Amendments to the Drawings

Serial No. 10/020,951 Amendment dated January 13, 2004 Replacement Sheet

FIG. 23A

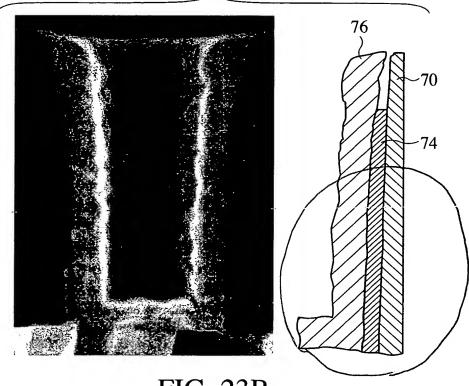
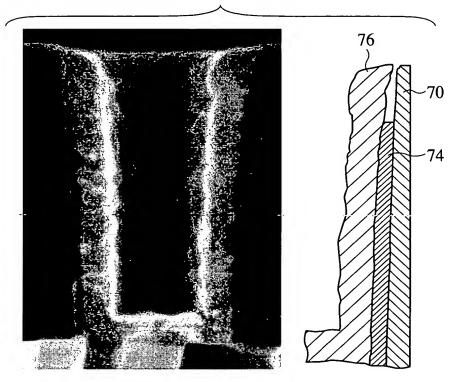
FIGS. 23A and 23B have been amended as shown in the attached "Replacement Sheet" and "Annotated Sheet Showing Changes."

These drawings have been amended to clarify the border portion between the bottom and side surface of the storage electrode. The amendments are based on the SEM image of FIGS. > 23A and 23B, and these amendments do not introduce new matter.

As described in lines 1-5 of page 39 of the present specification, the edge of the storage electrode shown in FIG. 23A is rounded and thickened in a substantially spherical and thickened configuration as shown in FIG. 23B. Also described in the specification and shown by the original SEM images of FIGS. 23A and 23B, the border between the bottom and the side surface is also rounded.
